RE: Menlo Park Proposed Hotel Narrative

Thank you for your consideration of the proposed hotel development located at 3723 Haven Avenue. The purpose of this letter is to request an additional planning commission hearing for architectural control. Since the project's approval at the initial planning commission hearing on November 14th, 2022, the design & engineering teams have been diligently working to ensure compliance with California Building Code, Accessibility codes, and local requirements. While working through these requirements, some portions of the building had to be updated to comply with code/engineering requirements.

MOXY BY MARRIOTT
MENLO PARK, CA
COMPARISON PLANS - 05-04-2023

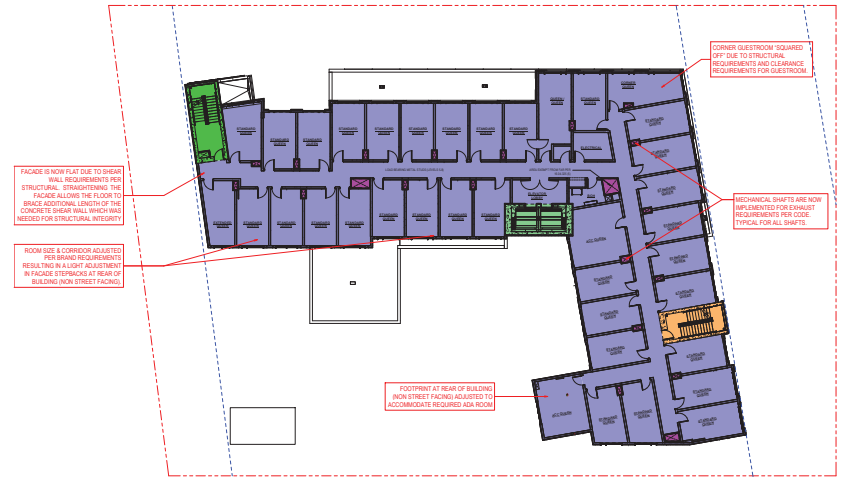
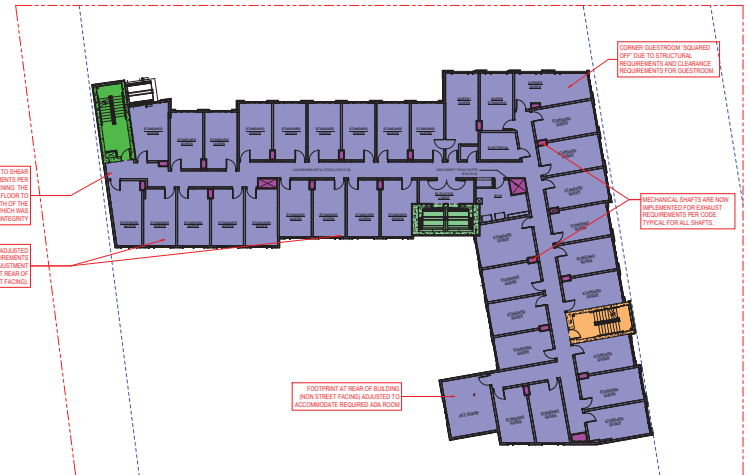
FACADE IS NOW FLAT DUE TO BEAR WALL REQUIREMENTS PER STRUCTURAL. STRENGTHENING THE FACADE ALLOWS THE FLOOR TO BRACE ADDITIONAL WEIGHT OF THE CONCRETE BEAR WALL WHICH WAS NEEDED FOR STRUCTURAL INTEGRITY

ROOM SIZE & CORRIDOR ADJUSTED PER BRAND REQUIREMENTS RESULTING IN A LIGHT ADJUSTMENT IN FACADE STEPPACKS AT REAR OF BUILDING (NORTH STREET FACING)

CORNER GUESTROOM SQUARED OFF DUE TO STRUCTURAL REQUIREMENTS AND CLEARANCE REQUIREMENTS FOR GUESTROOM

MECHANICAL SHAFTS ARE NOW IMPLEMENTED FOR EXHAUST REQUIREMENTS PER CODE TYPICAL FOR ALL SHAFTS

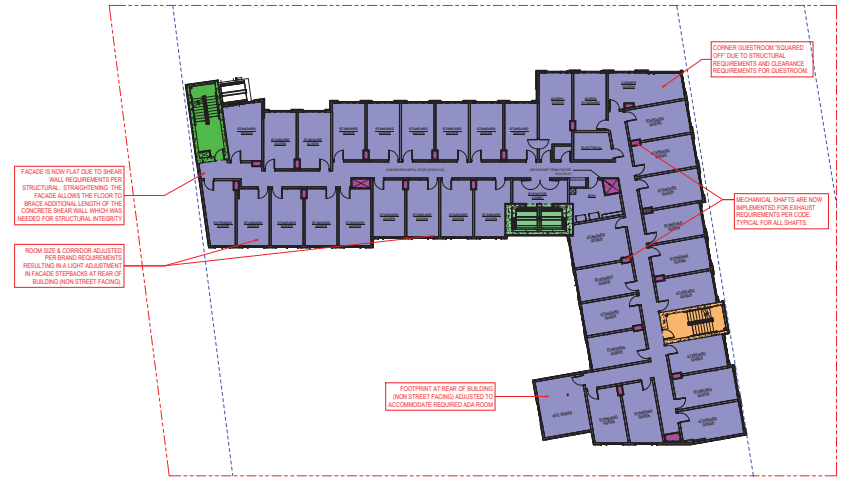
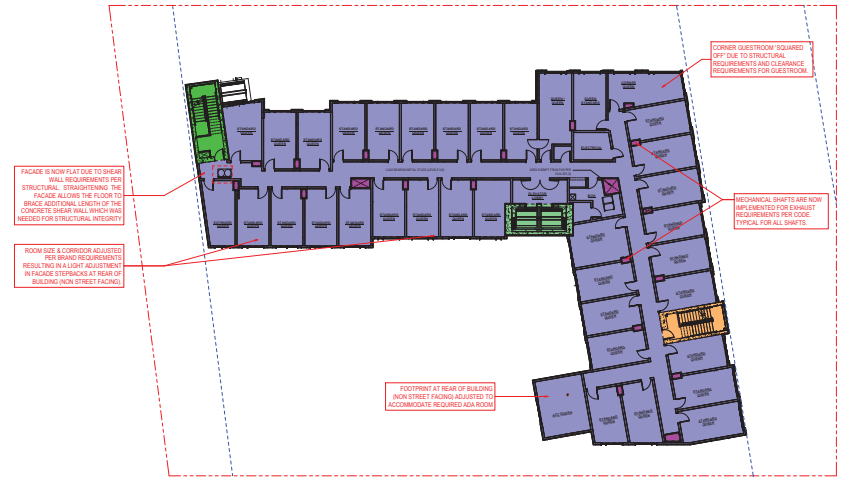
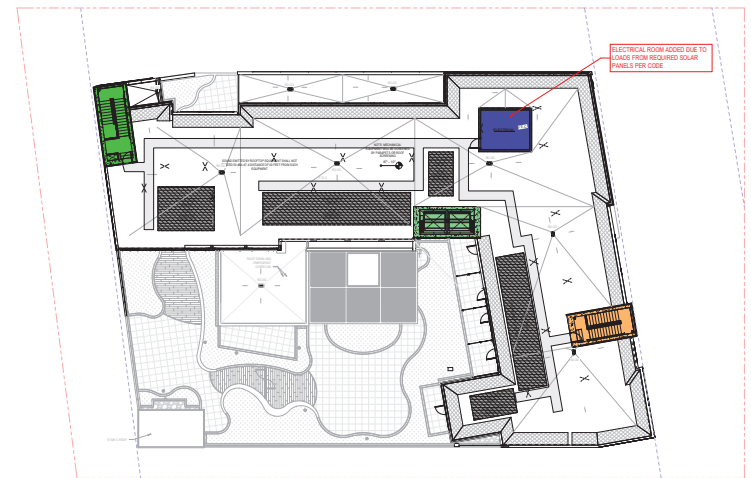
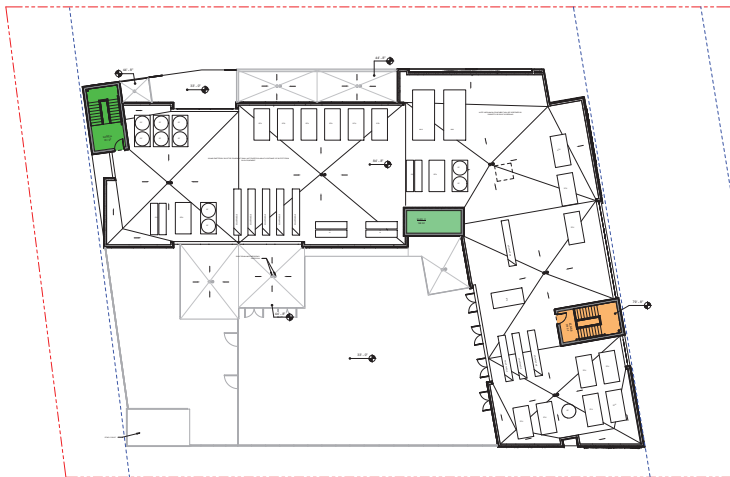
FOOTPRINT AT REAR OF BUILDING (NORTH STREET FACING) ADJUSTED TO ACCOMMODATE REQUIRED ADA ROOM

ELECTRICAL ROOM ADDED DUE TO
LOADS FROM REQUIRED SOLAR
PANELS PER CODE

LEVEL 1

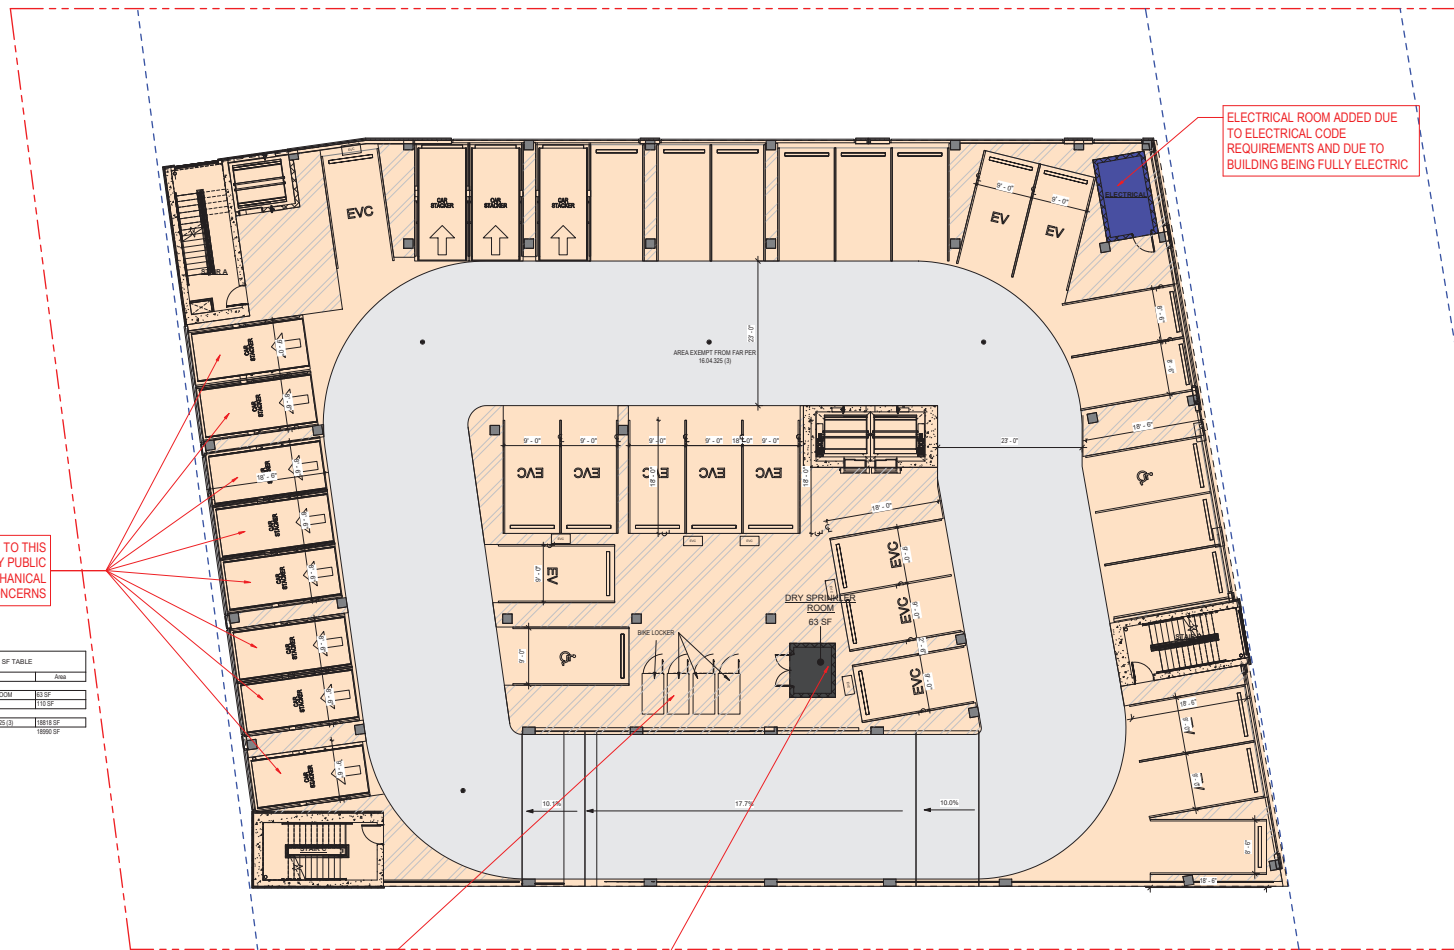
BOH AREA REDUCED AND INCREASED SPACE FOR COFFEE & LOUNGE

WATER SERVICE CLOSET ADDED FOR WATER ENTRY (INCLUDED IN FAR CALCULATION)

ELECTRICAL ROOMS HAD TO BE SHIFTED TO BE CLOSER IN PROXIMITY TO TRANSFORMER PER PGE CODE REQUIREMENT

STAIR & ELEVATOR WALL THICKNESS ADJUSTED PER STRUCTURAL REQUIREMENTS, TYPICAL FOR ALL LEVELS

DRY SPRINKLER ROOM ADDED PER NFPA 13 REQUIREMENTS (INCLUDED IN FAR CALCULATION)

MOVED VAN ACCESSIBLE SPACE HERE TO ACCOMMODATE PLAN CHANGES REQUIRED FOR ELECTRICAL ROOMS

STAIR DOOR LOCATION ADJUSTED

1. ELECTRICAL ROOMS HAD TO BE SHIFTED TO BE IN CLOSER PROXIMITY TO TRANSFORMER FOR ELECTRICAL CODE REQUIREMENTS.
2. DRY SPRINKLER ROOM ADDED PER NFPA 13 REQUIREMENTS (INCLUDED IN FAR CALCULATION)
3. WATER SERVICE CLOSET ADDED FOR WATER ENTRY (INCLUDED IN FAR CALCULATION)
4. BOH AREA REDUCED AND ADDED TO COFFEE & LOUNGE AREA
5. MOVED VAN ACCESSIBLE HERE TO ACCOMMODATE PLAN CHANGES REQUIRED FOR ELECTRICAL
6. STAIR DOOR LOCATION ADJUSTED
7. STAIR & ELEVATOR WALL THICKNESS ADJUSTED PER STRUCTURAL REQUIREMENTS

LEVEL 3

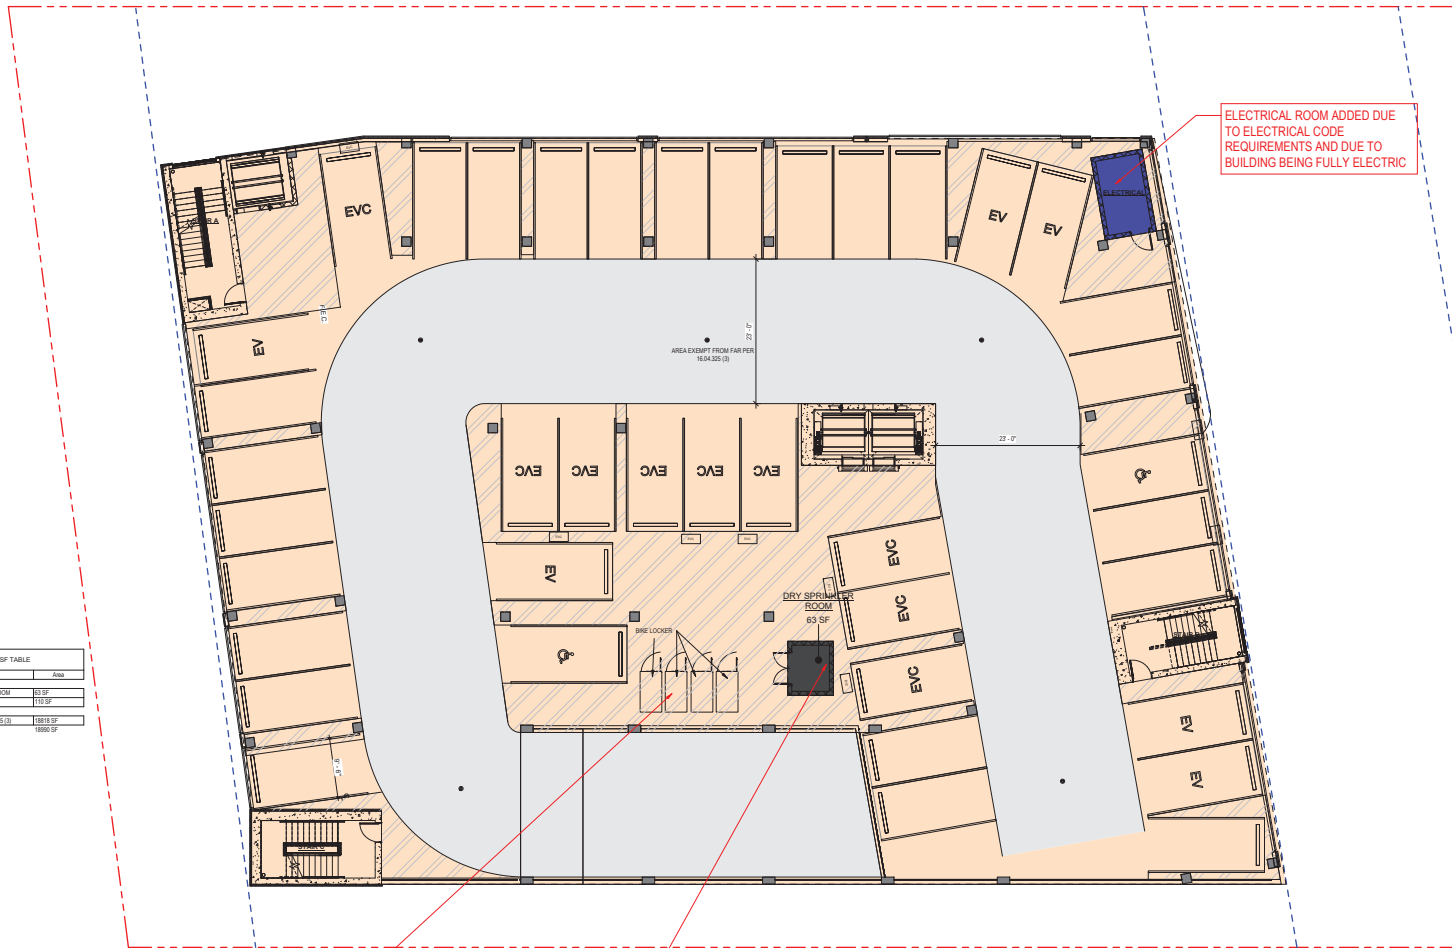
DRY SPRINKLER ROOM ADDED
PER NFPA 13 REQUIREMENTS
(INCLUDED IN FAR CALCULATION)

1. CAR STACKERS MOVED TO THIS LEVEL TO AVOID ANY PUBLIC INTERACTION WITH MECHANICAL EQUIPMENT FOR SAFETY CONCERNS.
2. ELECTRICAL ROOM ADDED DUE TO ELECTRICAL CODE REQUIREMENTS AND DUE TO BUILDING BEING FULLY ELECTRIC (INCLUDED IN FAR CALCULATION)
3. DRY SPRINKLER ROOM ADDED PER NFPA 13 REQUIREMENTS (INCLUDED IN FAR CALCULATION)

1. ELECTRICAL ROOM ADDED DUE TO ELECTRICAL CODE REQUIREMENTS AND DUE TO BUILDING BEING FULLY ELECTRIC (INCLUDED IN FAR CALCULATION)
 2. DRY SPRINKLER ROOM ADDED PER NFPA 13 REQUIREMENTS (INCLUDED IN FAR CALCULATION)

EAST (FRONT) ELEVATION

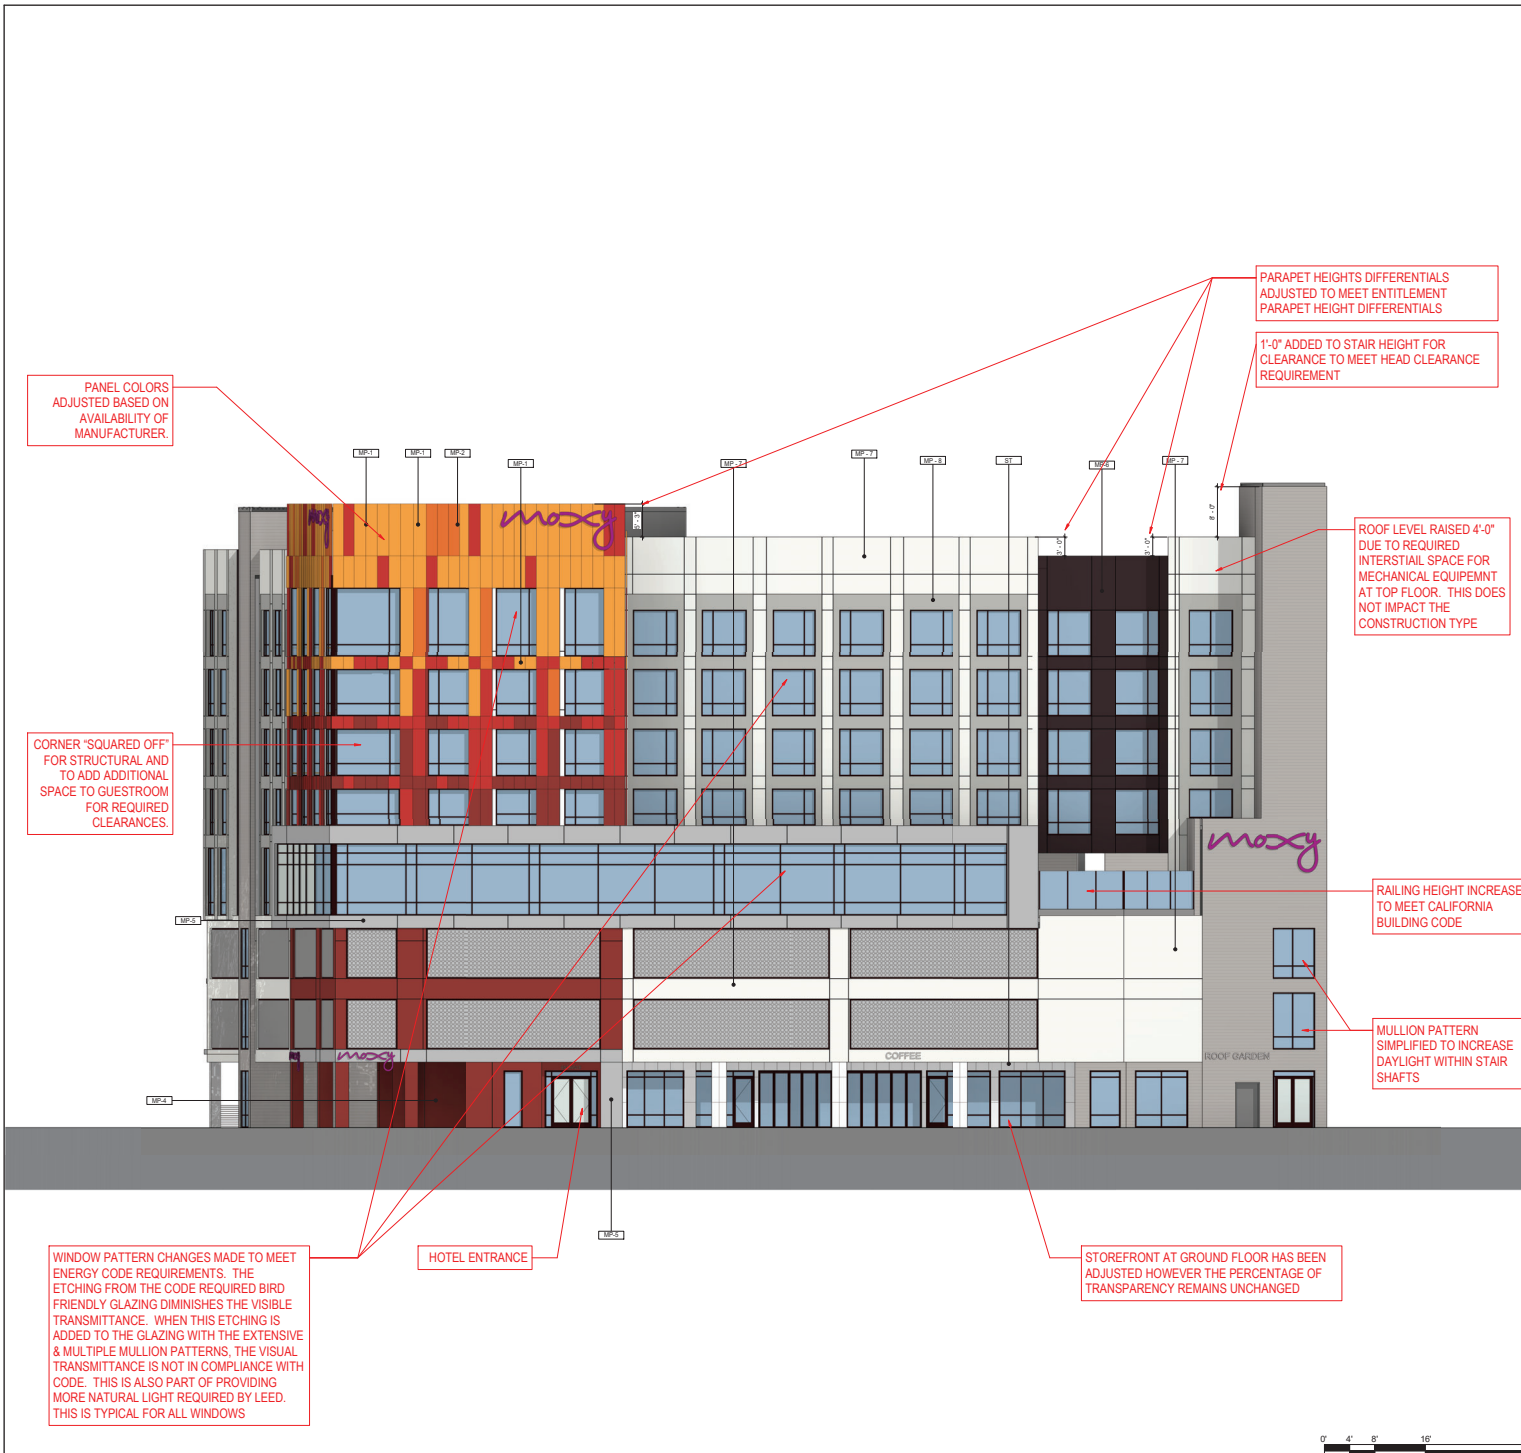
AREA AT LEVEL 1 ADJUSTED IN THIS
LOCATION DUE TO THE RELOCATION
OF ELECTRICAL ROOMS

ADDITIONAL COLUMN ADDED PER
STRUCTURAL REQUIREMENTS
